UNITED STATES PATENT AND TRADEMARK OFFICE

10/559,621

Office Action Summary	Application No. 10/559,621	Applicant(s) SLUNICK ET AL.	
	Examiner Fannie Kee	Art Unit 3679

3DETAILED ACTION

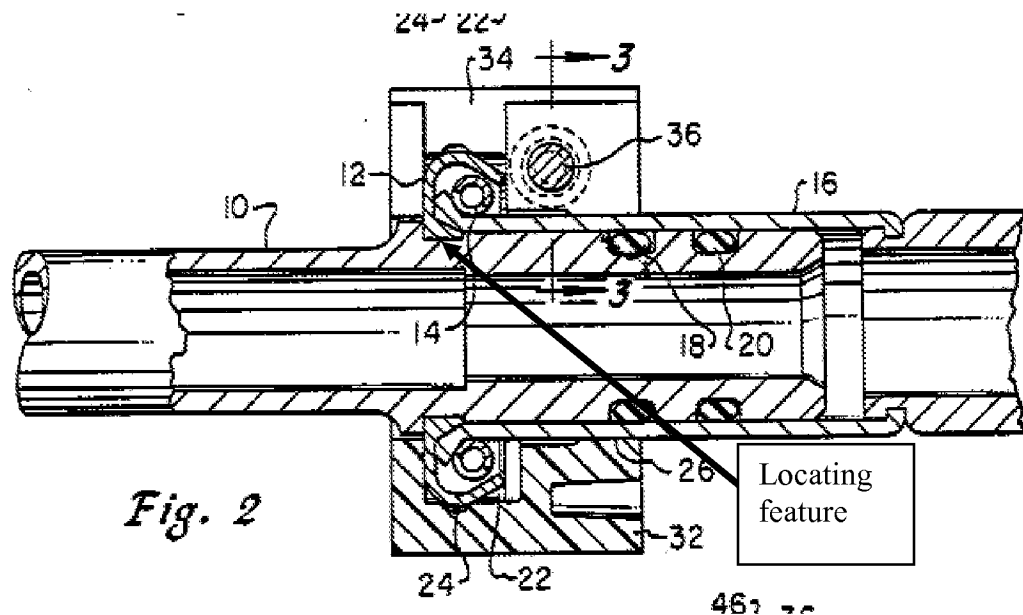
With regard to claim 1, and as shown in Figure 2 below, Smith discloses a fluid connection assembly comprising:

- a housing (10) including a fluid port;
- a tube (16);
- a seal (18) located between the tube and the fluid port;
- a retainer (12) to secure the fluid port to the tube; and
- a locating feature to prevent relative rotation between the fluid port of the housing and the tube.

However, Smith does not teach that the housing is made of a first material and the tube made of a second material dissimilar to the first material.

With regard to claim 8, and as shown in Figure 2 above, Smith discloses the fluid port includes at least one annular recess that receives the seal.

With regard to claim 9, and as shown in Figure 2 above, Smith discloses at least one of the fluid port and the tube including the locating feature, and the material of the retainer being received in the locating feature to prevent relative rotation between the fluid port of the housing and the tube.

preventing rotation between the fluid port of the housing and the metal tube (see locating feature in Figure 2 above).

With regard to claim 16, and as shown in Figure 2 above, Smith discloses the step of inserting the fluid port into the metal tube.

With regard to claim 17, and as shown in Figure 2 above, Smith discloses the step of preventing over insertion of the metal tube during the step of inserting the fluid port into the metal tube (the connection at 28 and 64).

With regard to claim 18, and as shown in Figure 2 above, Smith discloses the step of retaining including molding a retainer (90) over a joint of the metal tube and the fluid housing.

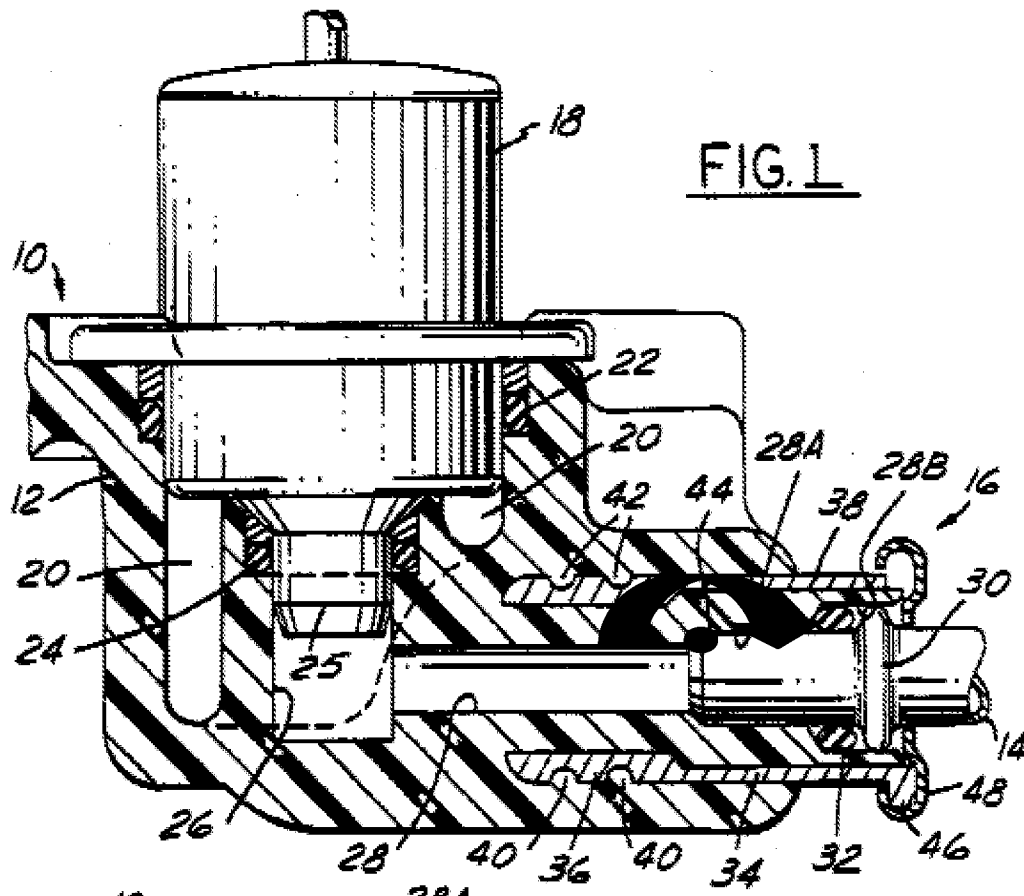
a. Applicant argues that Imoehl does not disclose a locating feature which is equivalent to Applicant's locating feature because it does not prevent relative rotation between the fuel rail 12 and the tube 14.

Applicant has not defined what type of relative rotation is being prevented. As shown below, the locating feature in Imoehl does prevent relative rotation between the fuel rail and the tube.

**FIGURE 1**

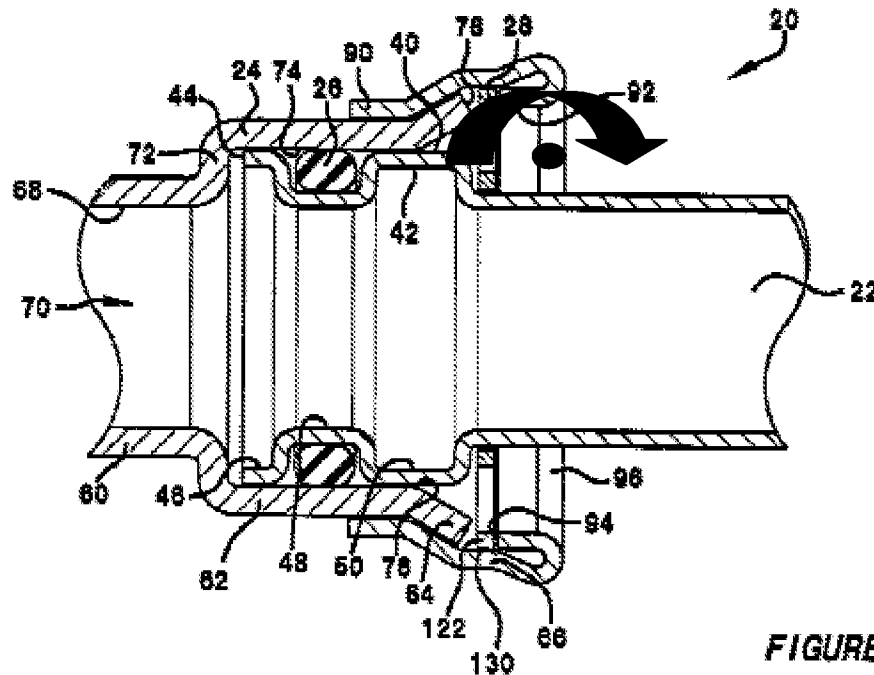
b. Applicant argues that Bartholomew does not disclose a locating feature which is equivalent to Applicant's locating feature because it does not prevent relative rotation between the fluid port of the housing and the tube.

Applicant has not defined what type of relative rotation is being prevented. As shown below, the locating feature in Bartholomew does prevent relative rotation between the fluid port of the housing and the tube.

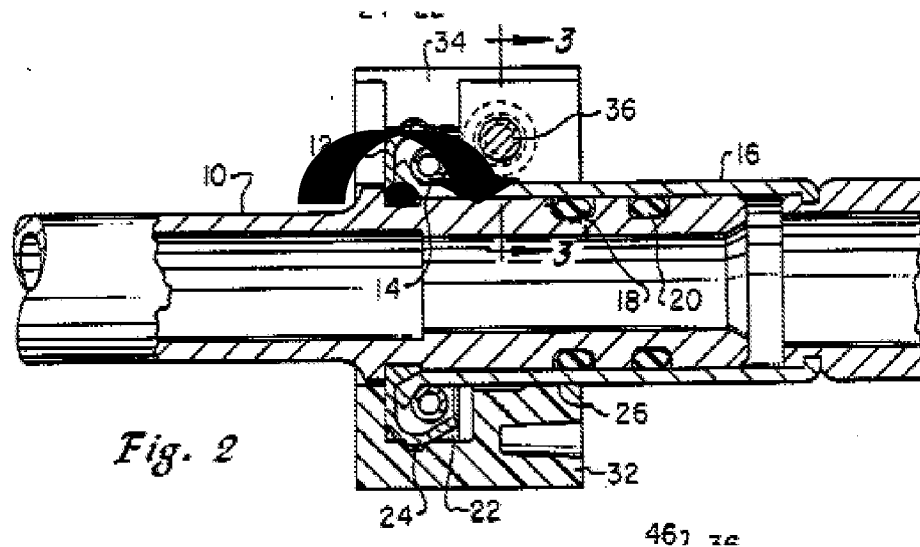
f. Applicant argues that Smith does not disclose a locating feature to prevent relative rotation between the fluid port of the housing and the tube.

Applicant has not defined what type of relative rotation is being prevented. As shown below, the locating feature in Smith does prevent relative rotation between the fluid port of the housing and the tube.
